GENERAL APPLICATION

Location Address: 5730 JOHNSON STREET, HOLLYWOOD, FLORIDA

QUADS PLAZA
PROP. 2 STORY MULTIFUSE BUILD.
AT
5730 JOHNSON STREET
HOLLYWOOD, FLORIDA

DATE: 09/10/2022
DRAWN BY DM
PROJECT NO. 2022-00129
REVISED BY MN
SHEET NO. A-3

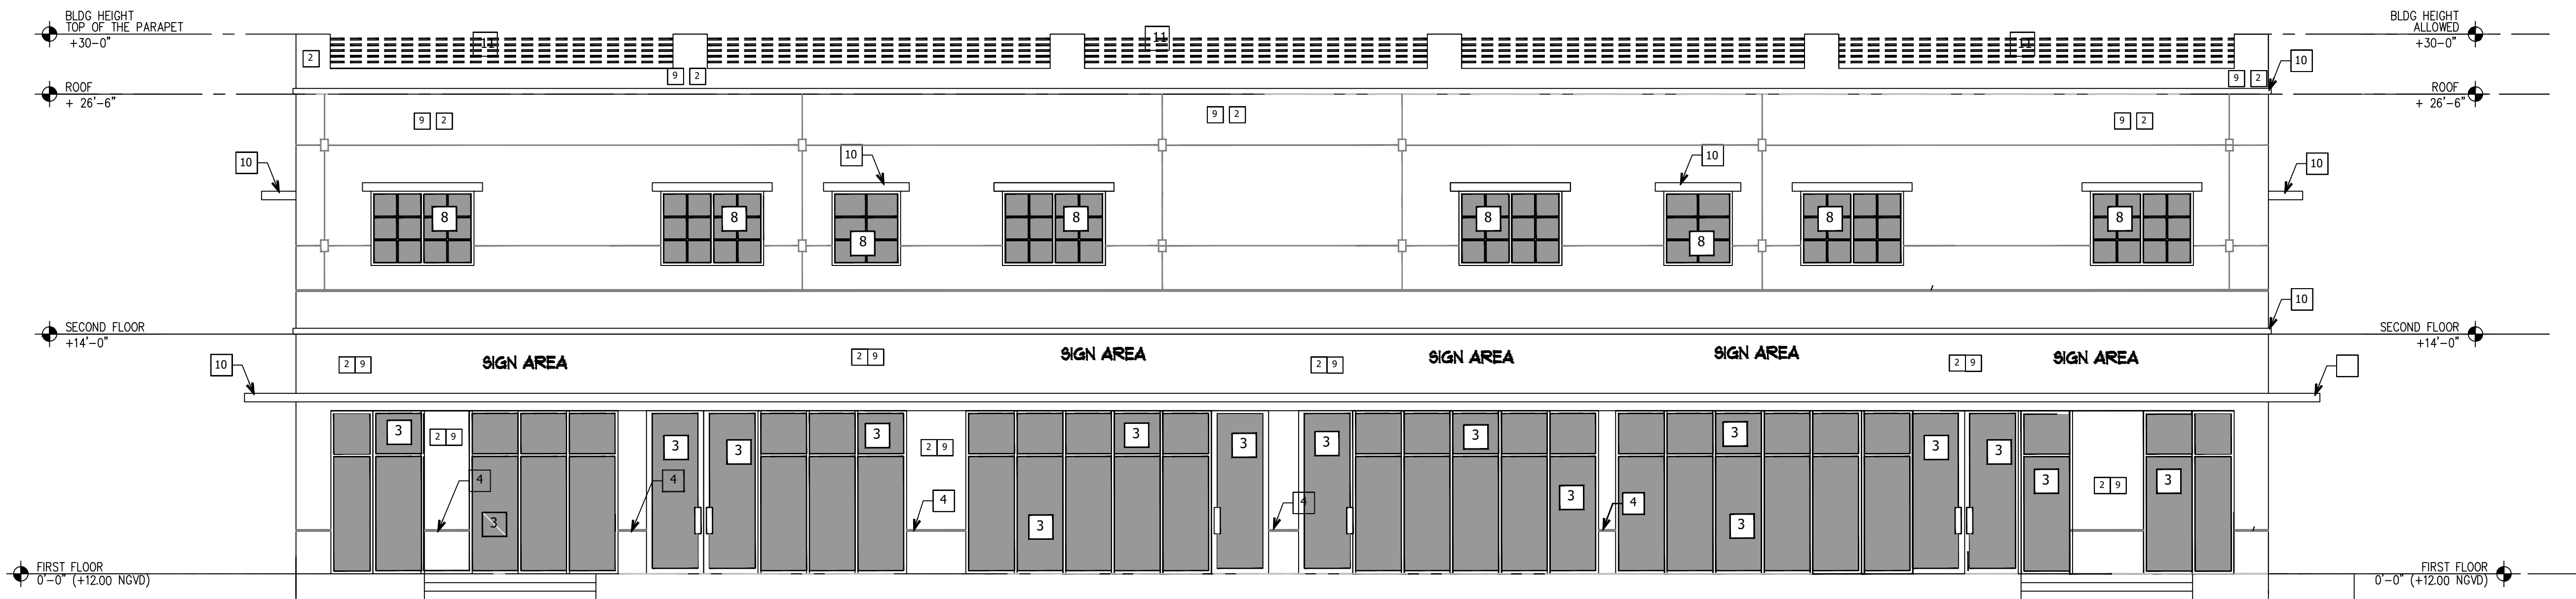
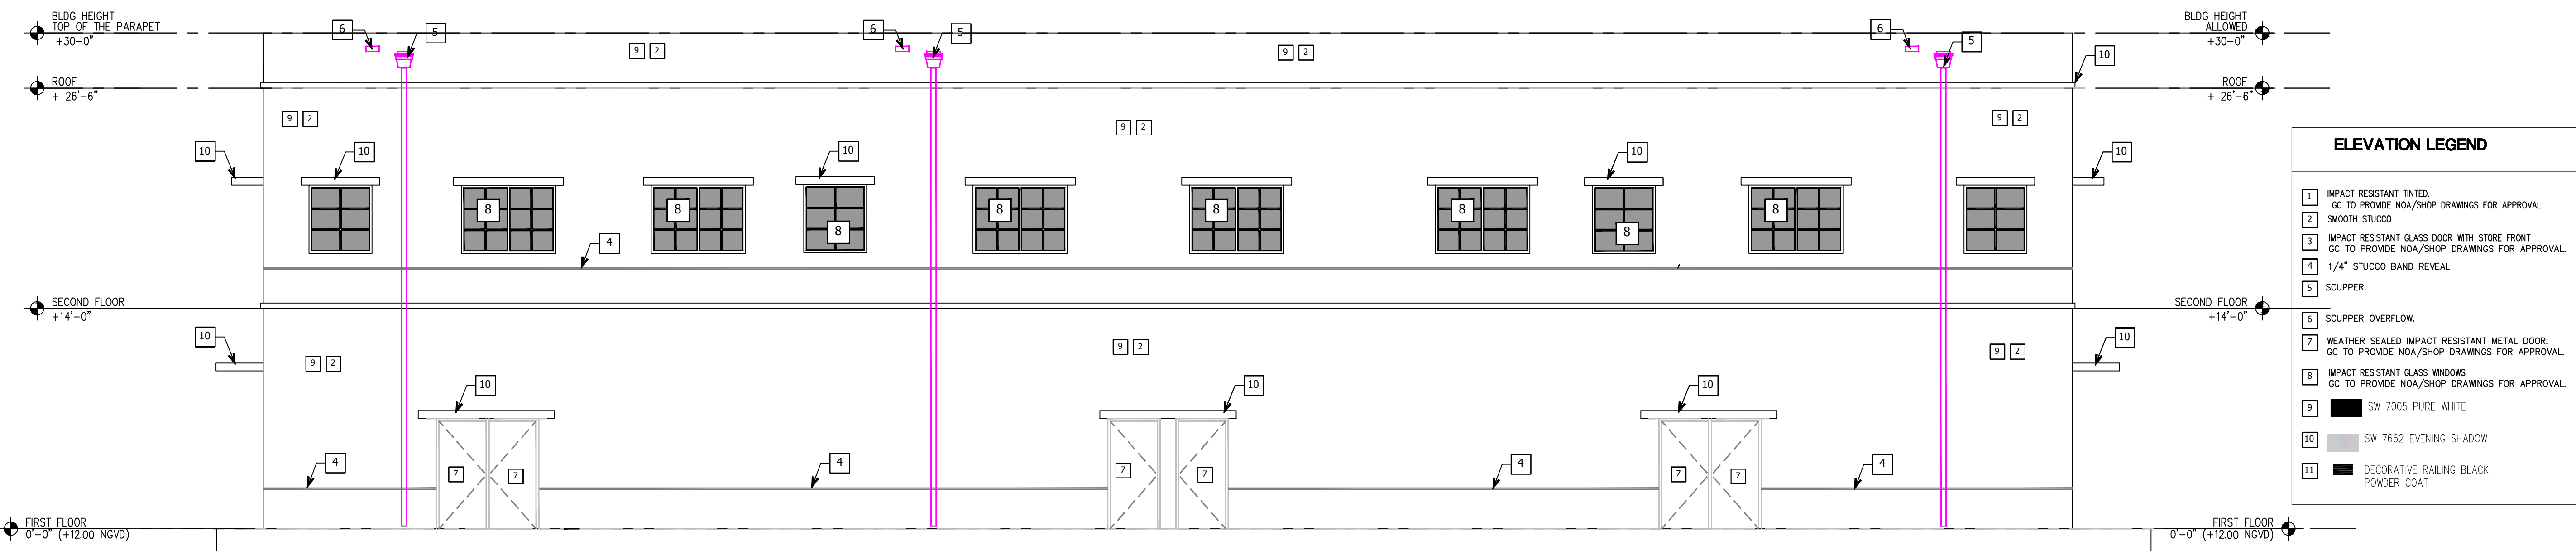
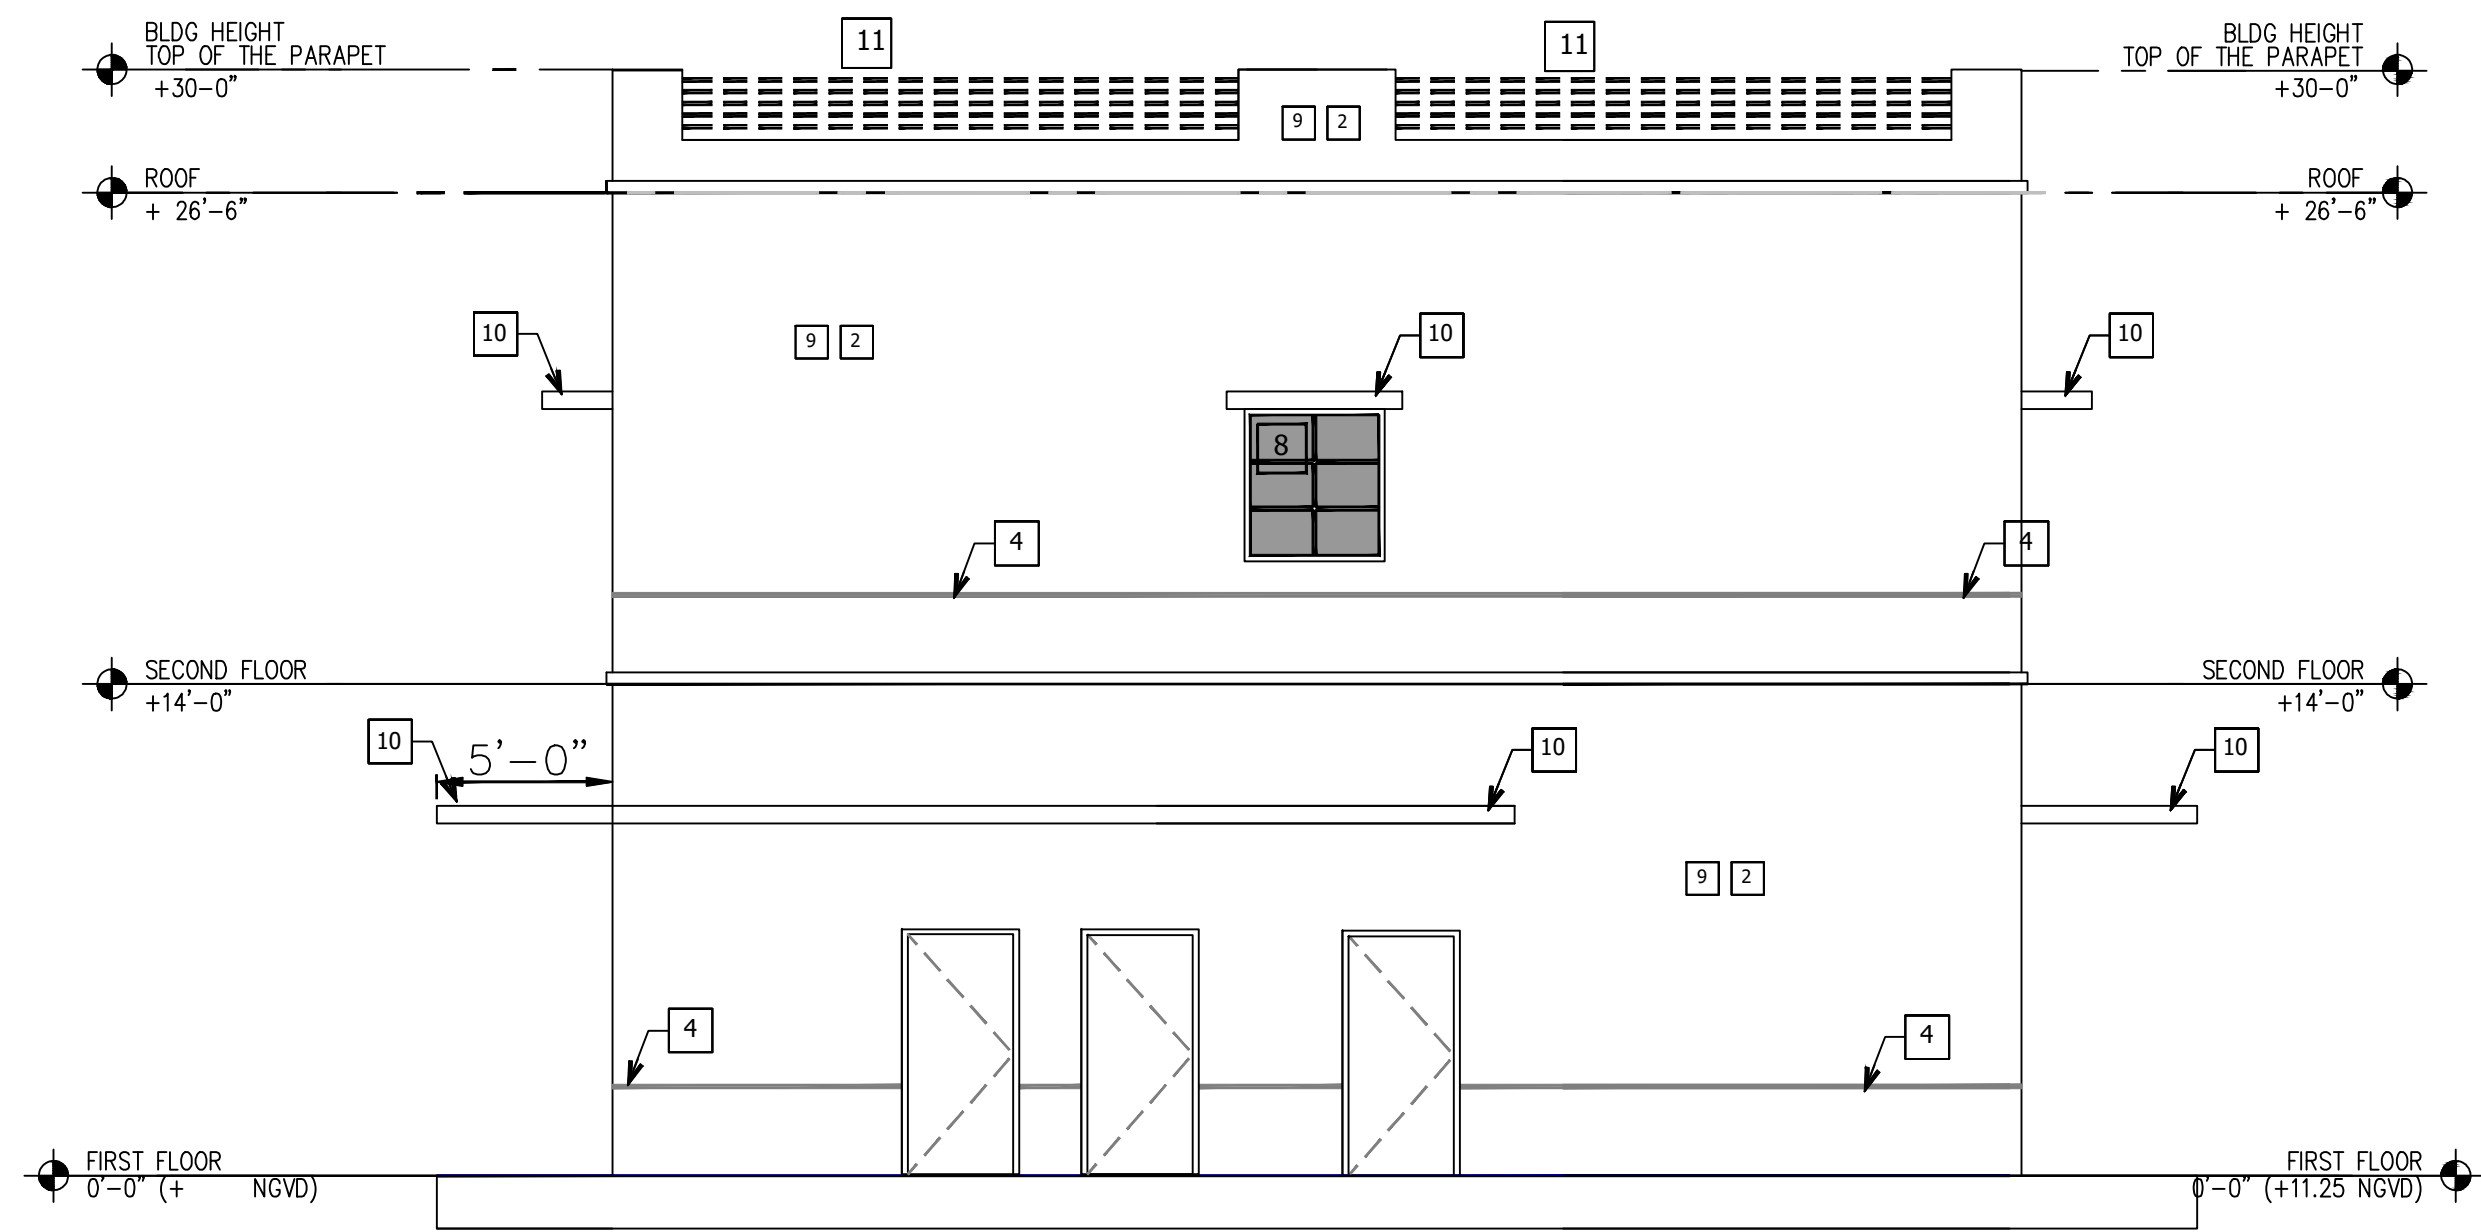
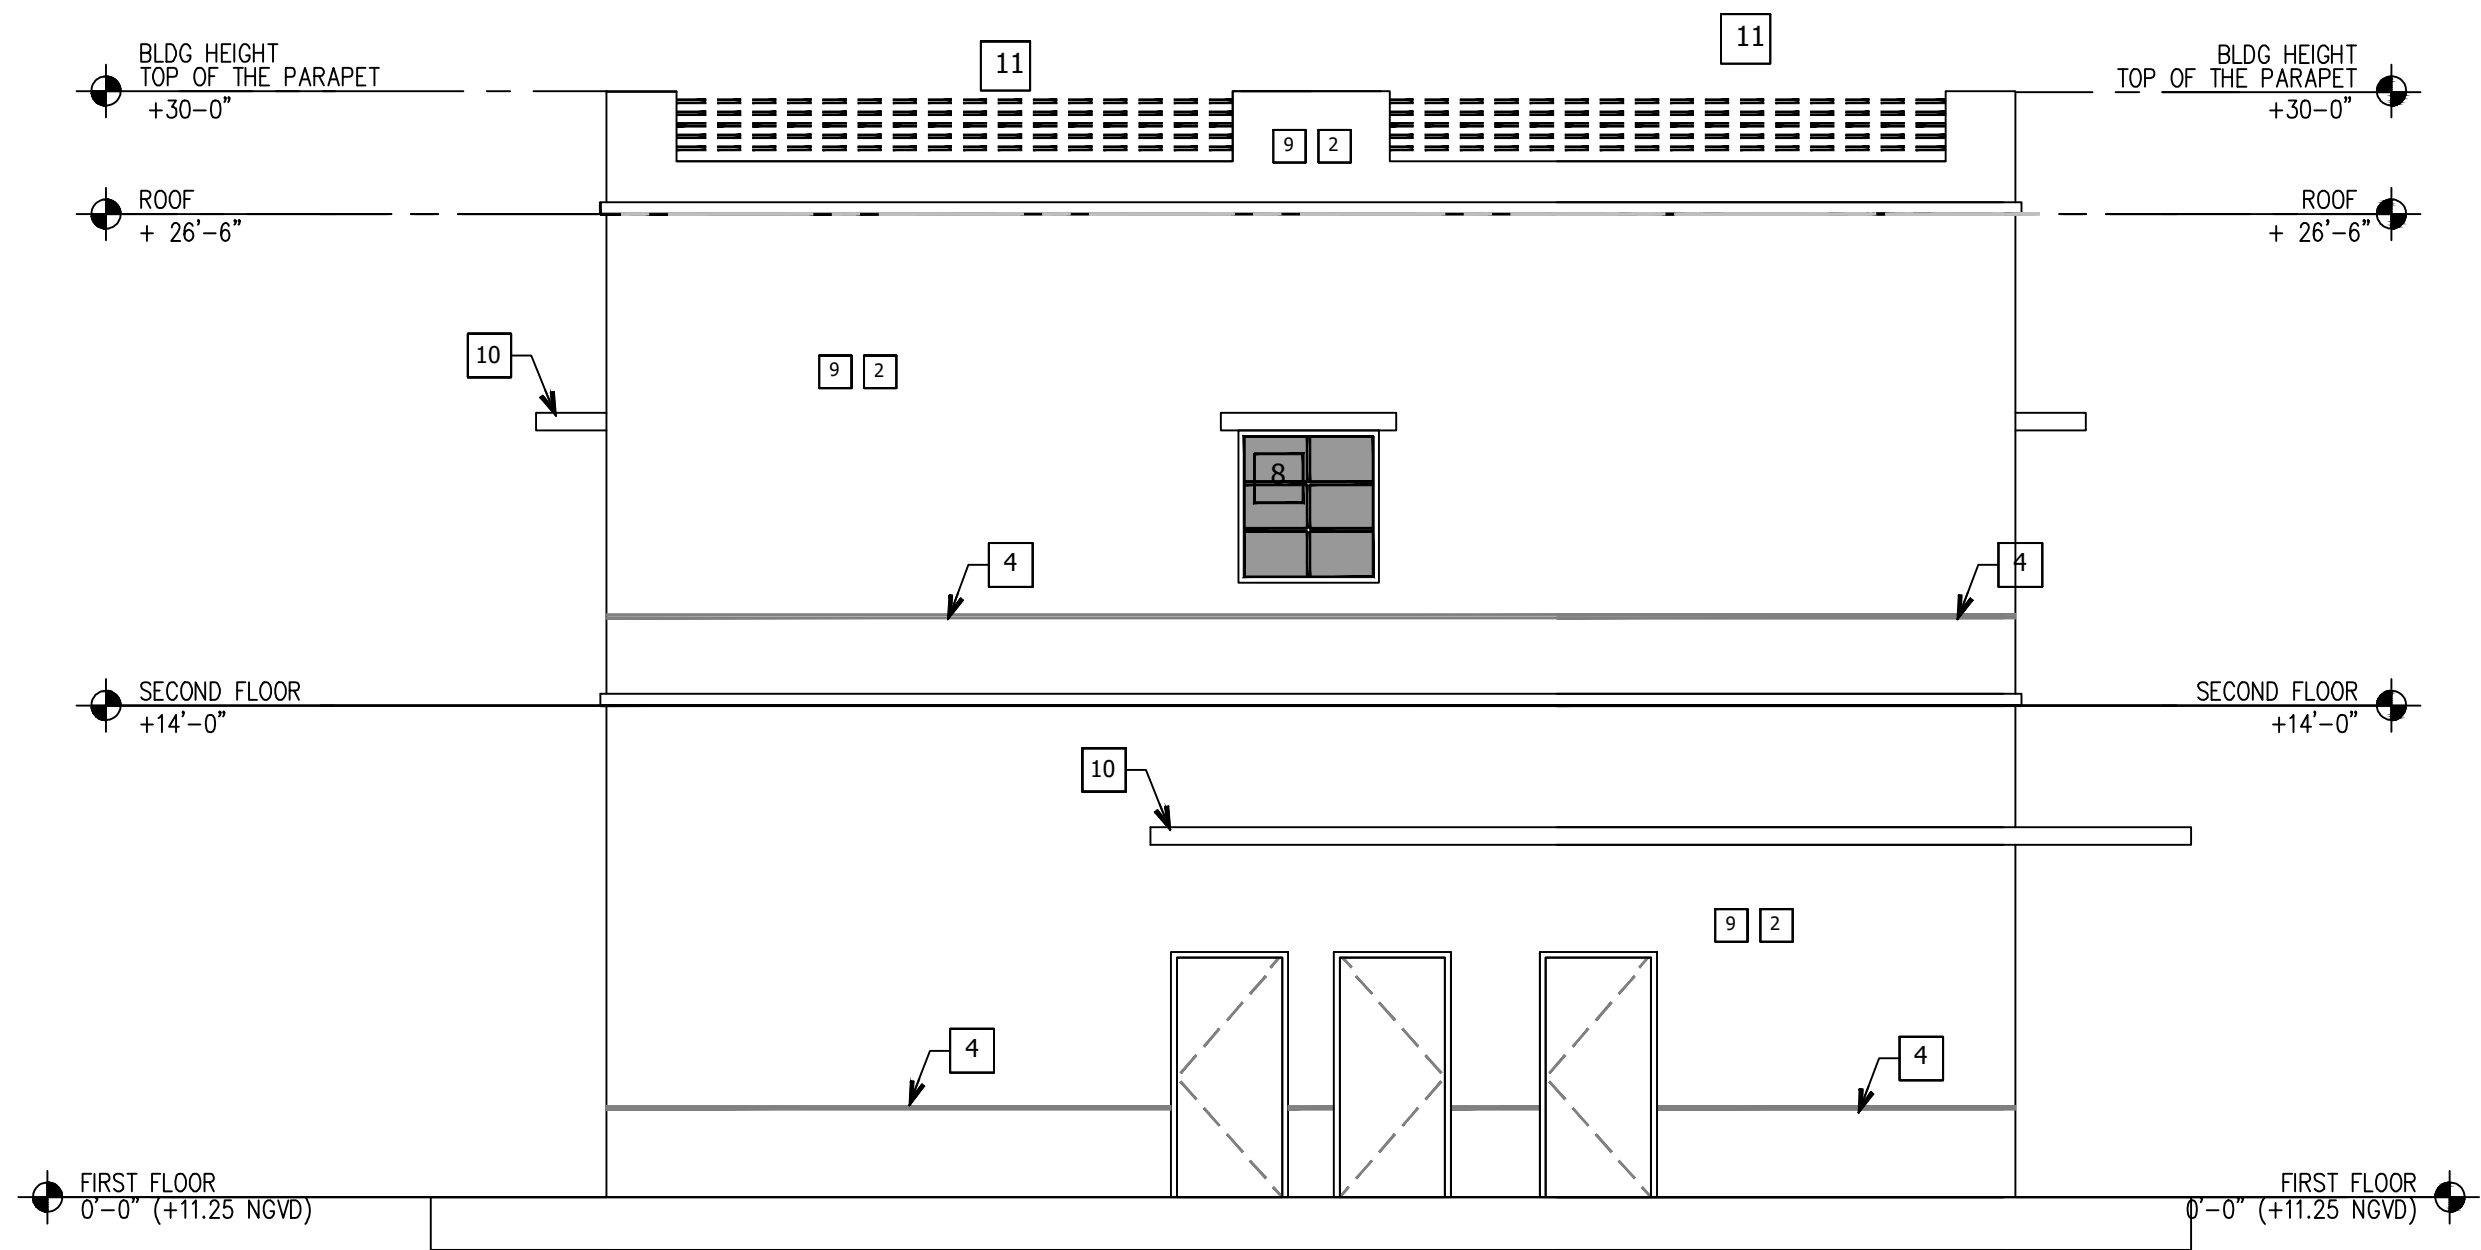
1. Provide color material legend on elevation sheets.

Response: Please find the materials legends on the elevation sheet A-3 and A-4.
